**Application for Permission Under Section 16 of the Town Planning Ordinance (Cap. 131) for Proposed Temporary Educational Institution (Teaching Farm) and Associated Excavation of Land for a Period of Three Years at Various Lots in D.D. 16, Wo Tong Pui, Tai Po, New Territories
(Planning Application No. A/NE-LT/794)**

Submission of Further Information

Responses-to-Comments table

Responses to Comments – Departmental Comments (September 2026)

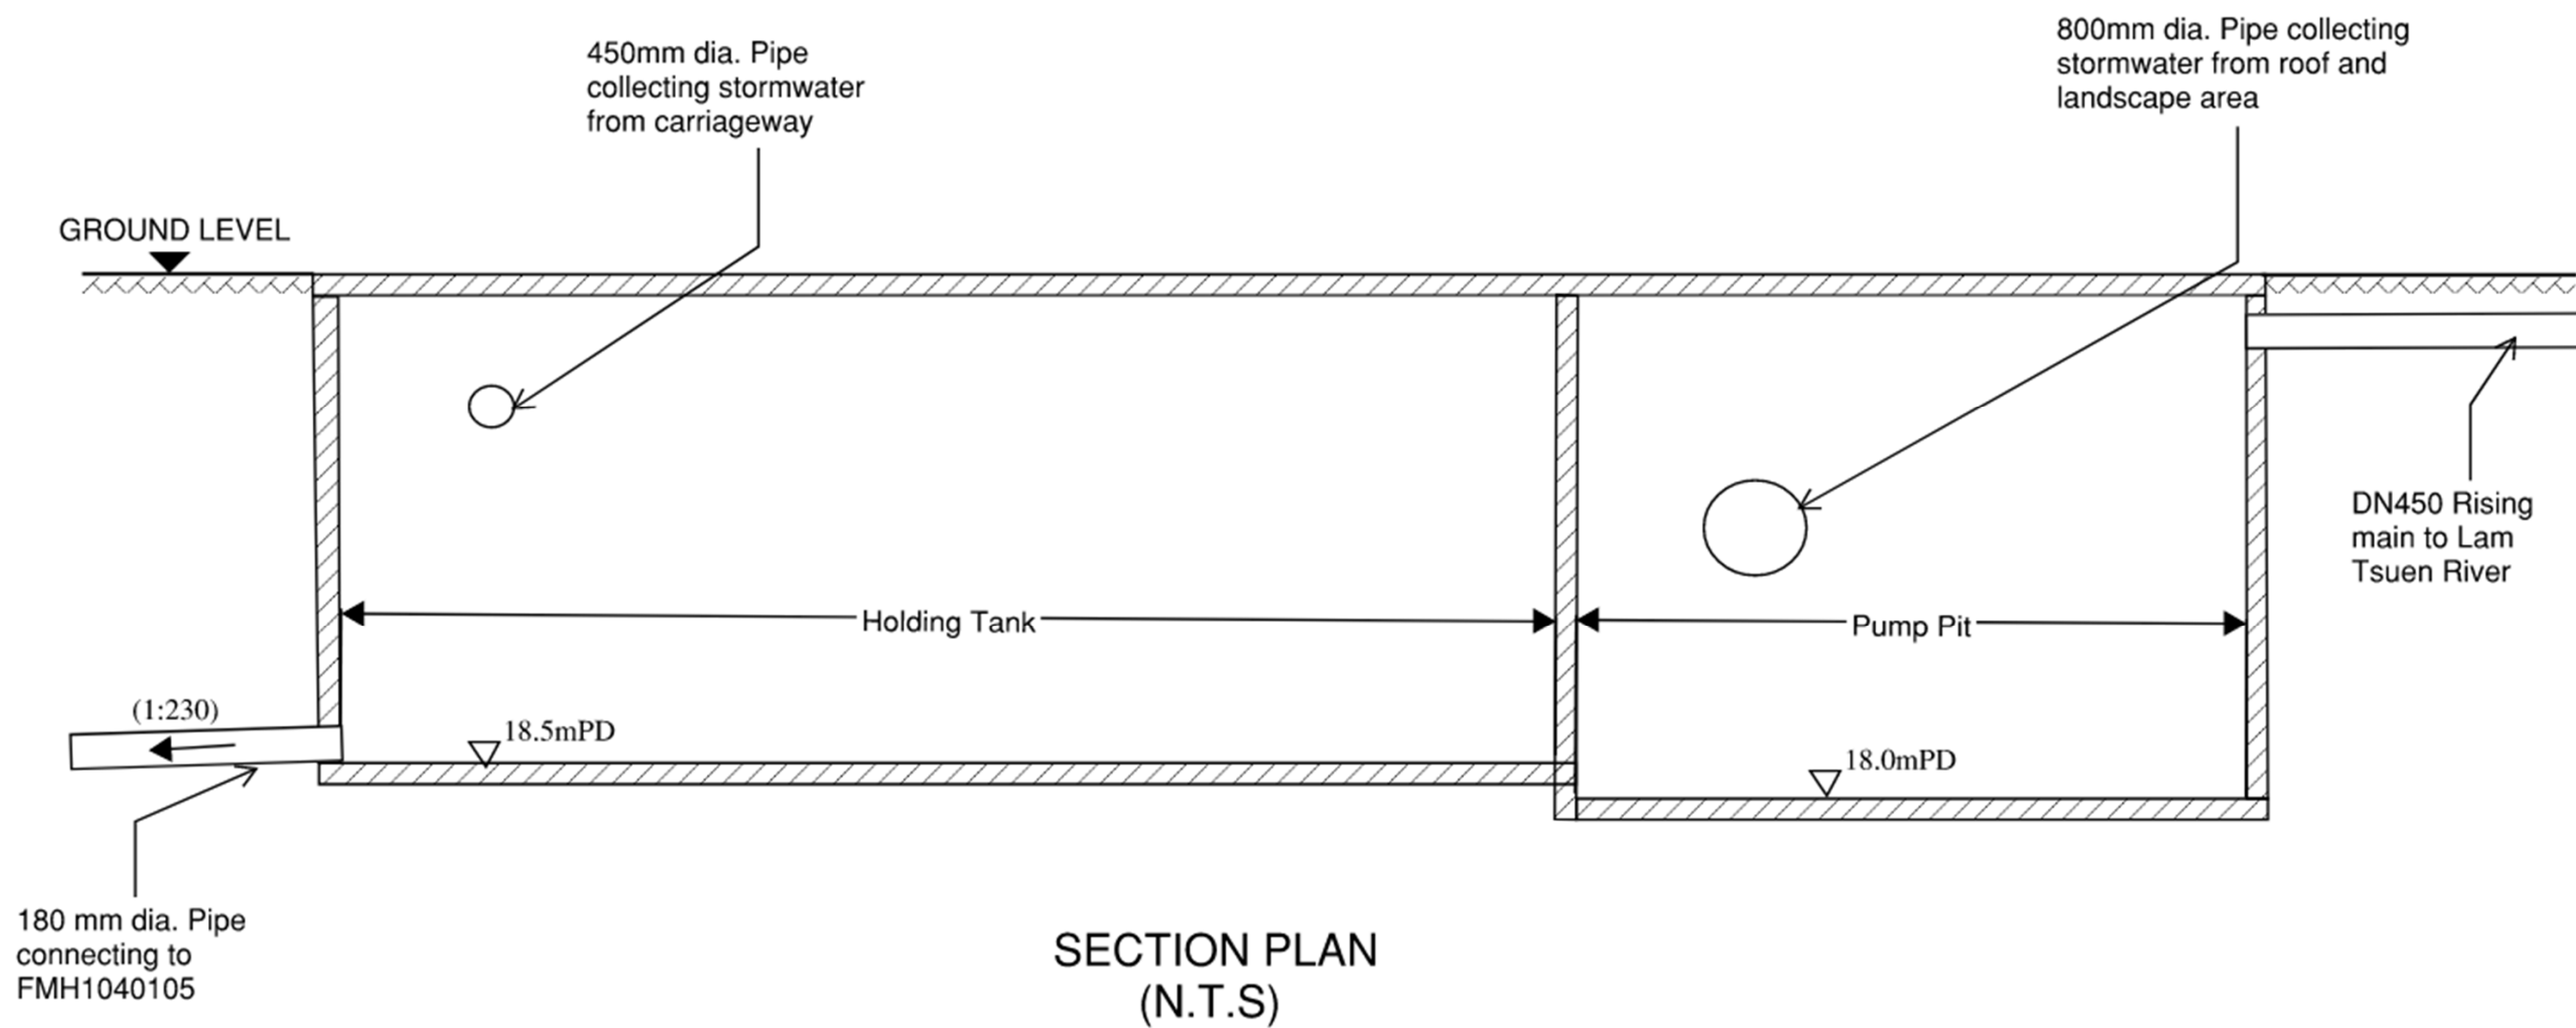
No.	Comments	Responses
	should be considered in the calculation. c) Figure No. B4 — Please demonstrate how the holding tank can collect the first flush only. With the current arrangement, after collecting the first flush, the incoming water will mix with the first flush and thus become contaminated water when overflow the weir to the pump pit. d) Catchpits should be provided at <u>all</u> turning point of U channel. e) Please clarify whether the outfall is submerged at Lam Tsuen River. If not, a pressure release chamber should be provided before discharging to Lam Tsuen River. f) RtoC (e) — The surface runoff from the surrounding areas passing through the site area should be included in the calculation. In addition, if this application has been approved for temporary use for 3 years, there may be a potential of further application for renewal of this use in the future. Therefore, as per Table 28 of Corrigendum No. 1/2022 of the SDM, the rainfall increases due to climate change by the end of the 21st century (16.0%) should be considered in the design. Furthermore, Table 31 of the same Corrigendum specifies that a design allowance for a rainfall increase of 12.1% (by the end of the 21st century) should be incorporated into the design. Sewerage Impact Assessment Comments from Land Drainage Division (LDD), DSD	channel, no hillside stormwater will discharge into the application site. In view of the above, it is considered reasonable to exclude the existing catchment from the calculation. The holding tank design is updated. There will be no overflow between the holding tank and the pump pit. Please refer to Appendix B for the replacement pages of the updated DSIA. The details of the drainage design within the site boundary will be submitted for BD's approval. All the drainage systems within the site will be managed by CityU Farm and will not be handed over to DSD. Noted, pressure release chamber will be provided before connecting to the public outfall. Please refer to Appendix B for the replacement pages of the updated DSIA. Please refer to the RtoC (a) and (b), the surface runoff from the surrounding area has been intercepted by existing government channel and it will not pass through the site. In view of the above, it is considered reasonable to exclude the existing catchment from the calculation. Please note that the proposed development is intended for temporary teaching farm use over the coming three years only, while the long-term use of the site has yet to be confirmed. On this basis, and having regard to the relatively short planning horizon, it is considered reasonable that the climate change factor is not applied in this submission.

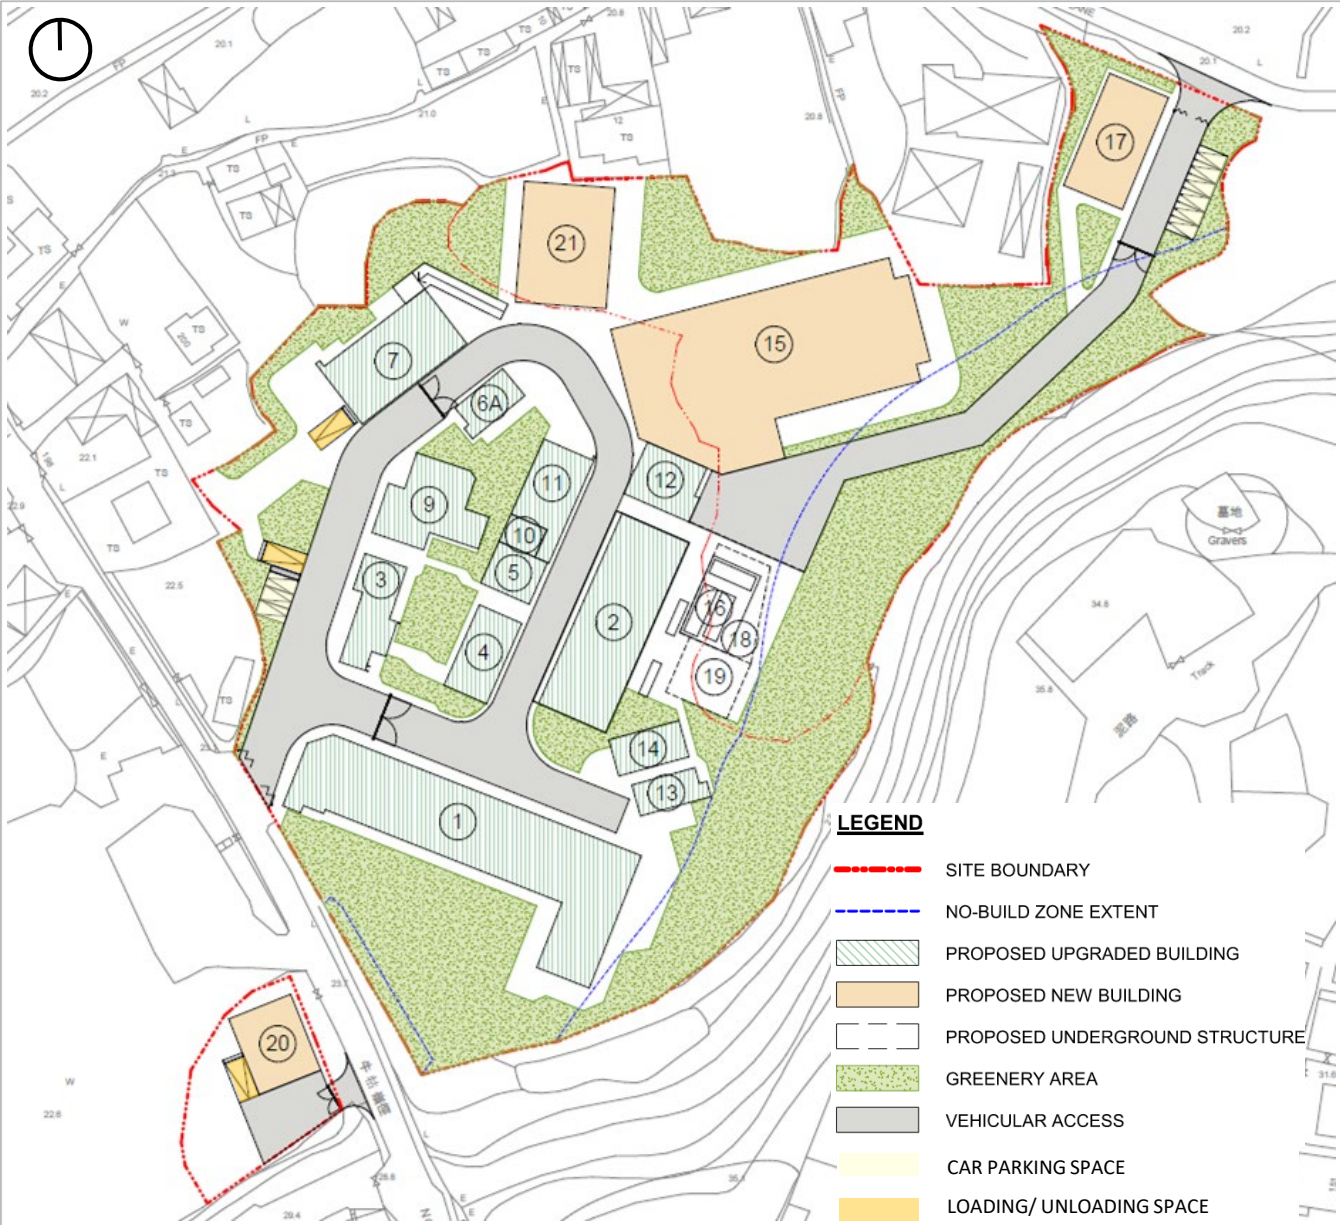
No.	Comments	Responses
	1. Table 4.3.2 and Figure No. 4.1: The name of Block 6A is indicated as "Machine Store" in the Table 4.3.2, but on Figure No. 4.1 as "Manure Store Block". Please clarify.	Noted, Block 6A should be referred to as "Machine Store". Figure No. 4.1 has been updated accordingly to ensure consistency with Table 4.3.2. Please refer to Appendix D for the replacement pages of the updated SPS.
